Inspection Report

Minerals Regulatory Program

Mine Name: DKG Quarry

Permit number: M/015/041

Photo 1. Panorama of the main part of the regraded area. Note the roughness and the depression in the lower right.

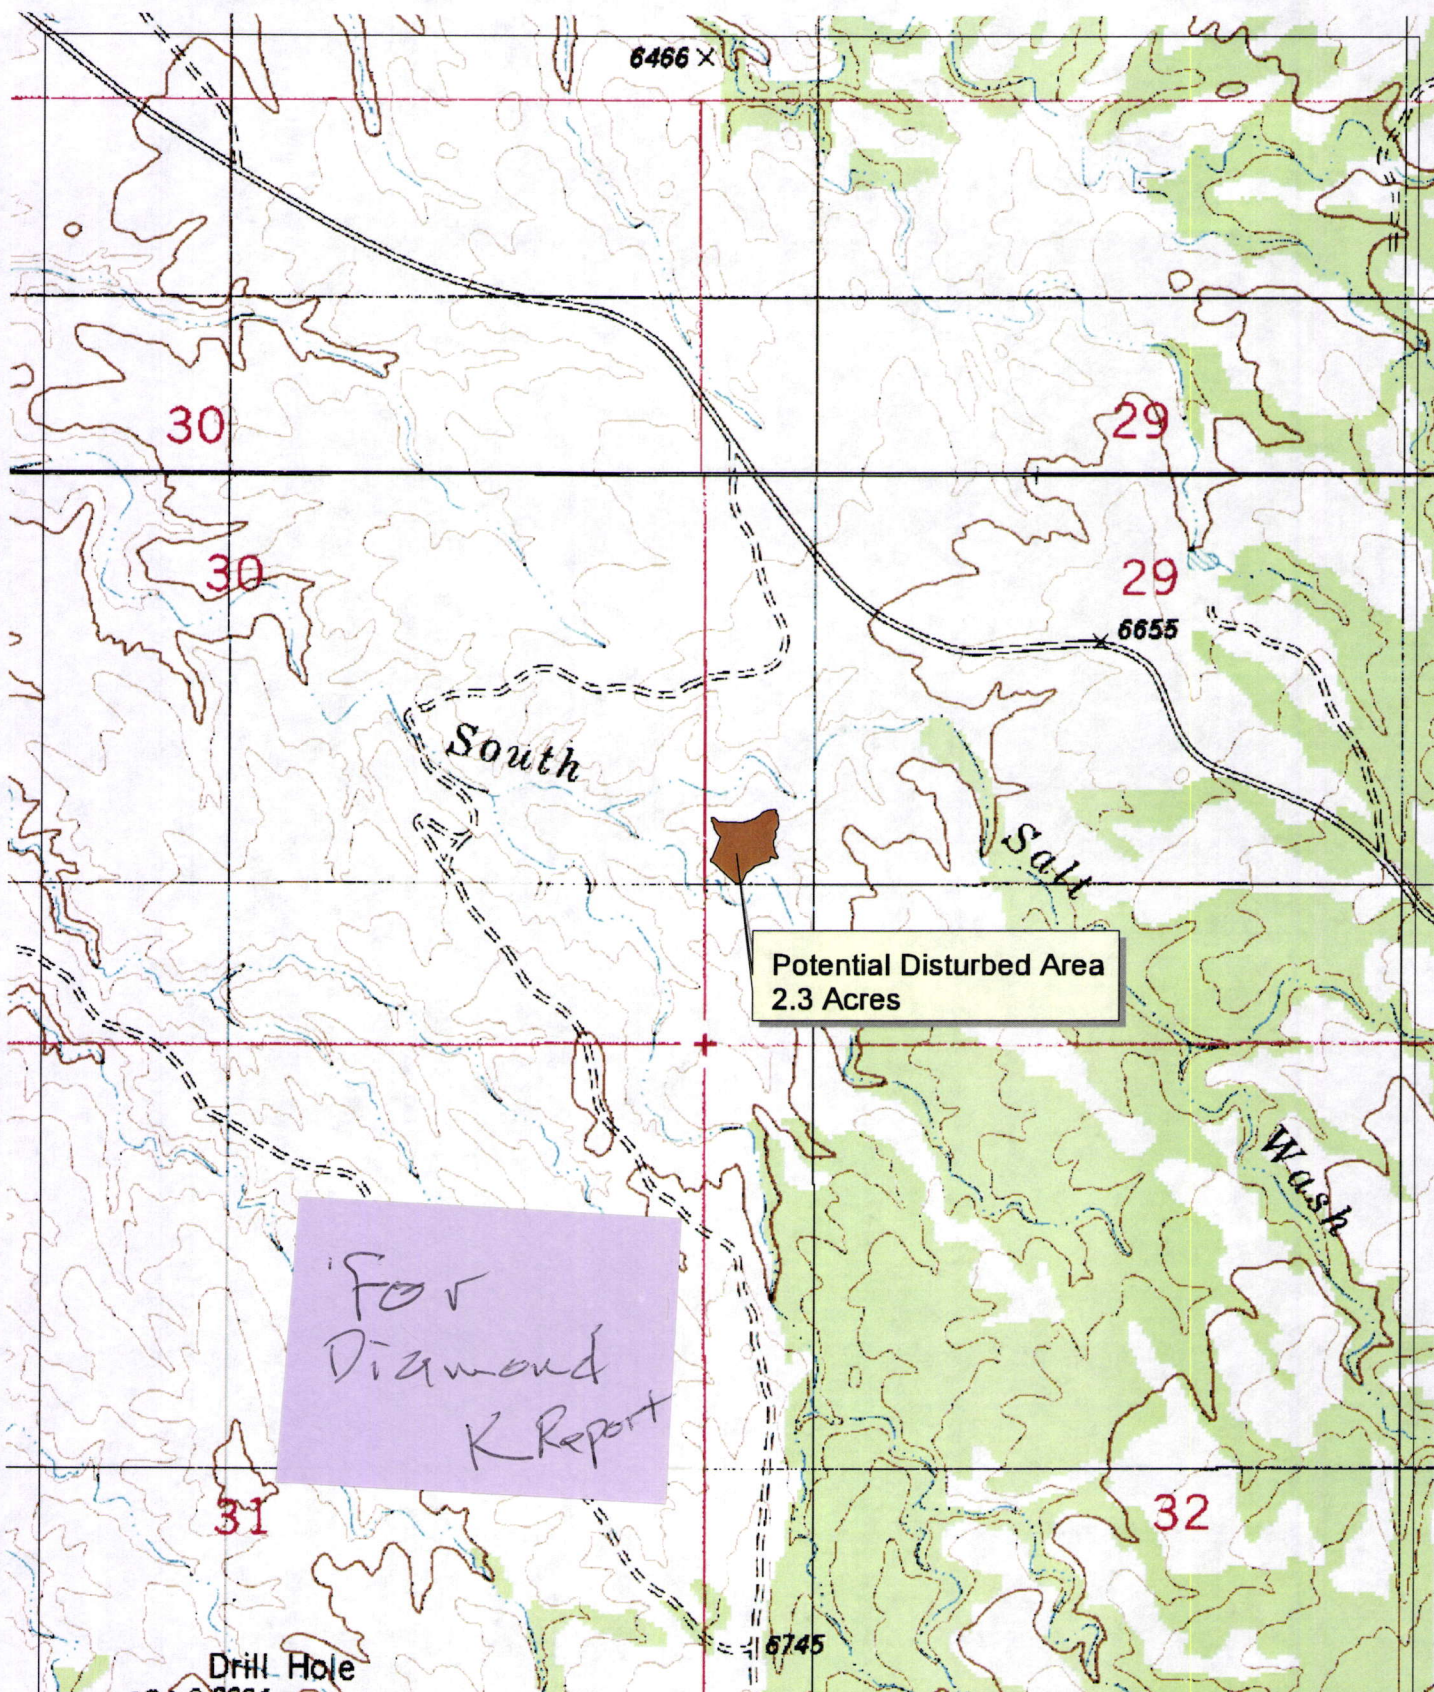
I am pleased with the grading that has been done (Photo 1). The site resembles adjacent undisturbed areas, and it is very rough. There is a small swale in the southwest part of the area that should collect runoff from most of the reclaimed area, but because the site is so rough, I do not anticipate much runoff.
